AMENDMENT OF SOLICITATION/MODIFICATION OF CONTRACT			1. CONTRACT ID CODE	PAGE OF PAGES 1 4
2. AMENDMENT/ MODIFICATION NO. A00004	3. EFFECTIVE DATE 12/28/95	4. REQUISITION/ PURCHASE REQ. NO.		5. PROJECT NO. (If applicable) CIN-01

14. DESCRIPTION OF AMENDMENT/ MODIFICATION (Organized by UCF section headings, including solicitation/ contract subject matter where feasible.) The following change is made to the above numbered contract for the Lake Pontchartrain, Louisiana and Vicinity, Floodproofing Veterans Boulevard Bridges over 17th Street Canal, Orleans and Jefferson Parishes, Louisiana, to revise the waterstop placement in the girders. A savings in cost of \$56,728.22 will be realized. The Government will share 45% (\$25,527.70) and the Contractor will share 55% (\$31,200.52).				
Except as provided herein, all terms and conditions of the document referenced in Item 9A or 10A, as heretofore changed, remains unchanged and in full force and effect.				
15A. NAME AND TITLE OF SIGNER (Type or print) PAUL SCHARMER AREA MANAGER		16A. NAME AND TITLE OF CONTRACTING OFFICER (Type or print) CHESTER ASHLEY, ADMINISTRATIVE CONTRACTING OFFICER

CHANGE TO THE DRAWINGS: Revise contract drawing 35

SK-95-0093-01

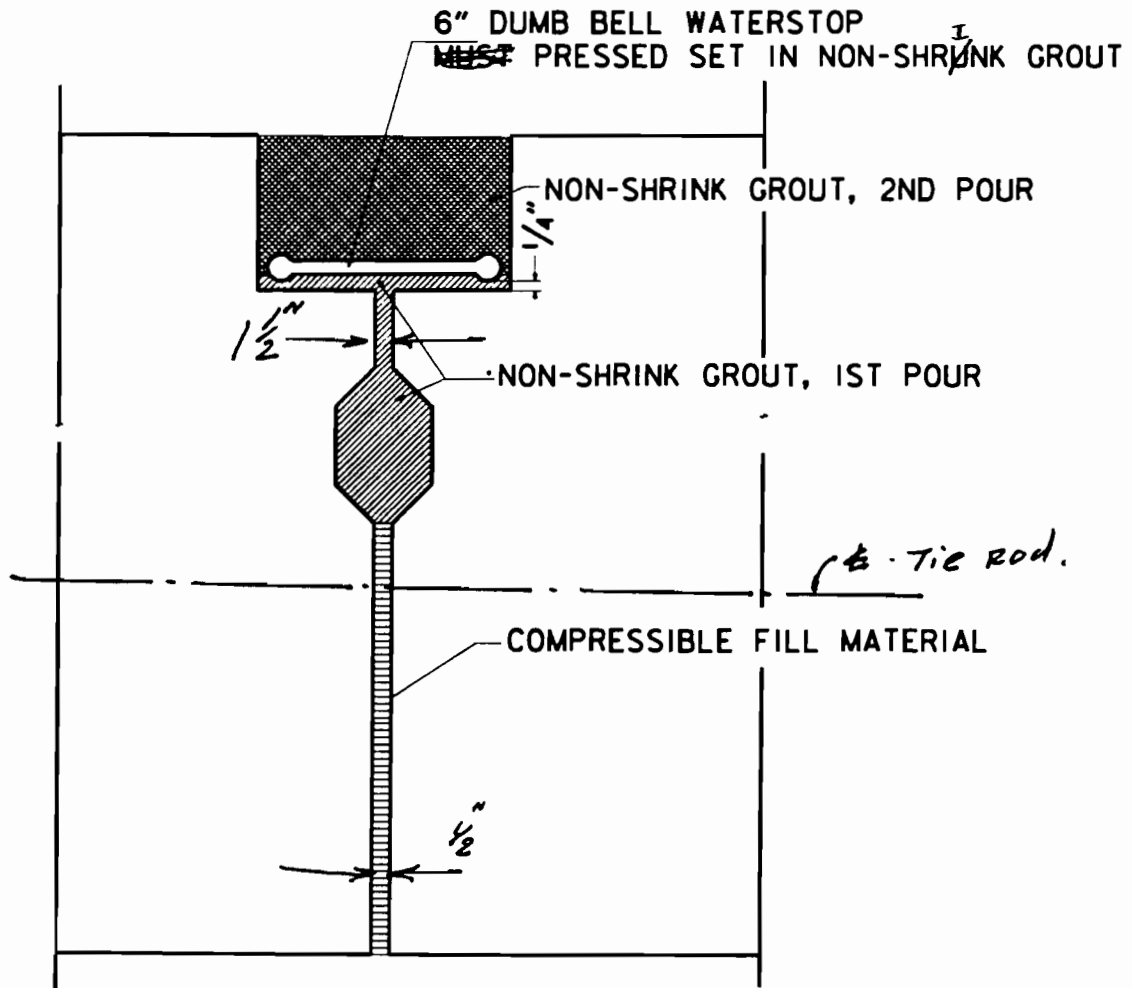
- Note: ① Press waterstop into 1st Pour of Non-shrink Grout before it is set. No air shall be trapped under waterstop.
- ② After 1st pour has set, fill blockout with 2nd pour of Non-shrink Grout.

5. Non-shrink Grout shall be used in lieu of Epoxy.

5.6. Placement. It shall be permitted that the 2nd pour of the non-shrink grout could be placed at the same time as the first, after placing the waterstop.
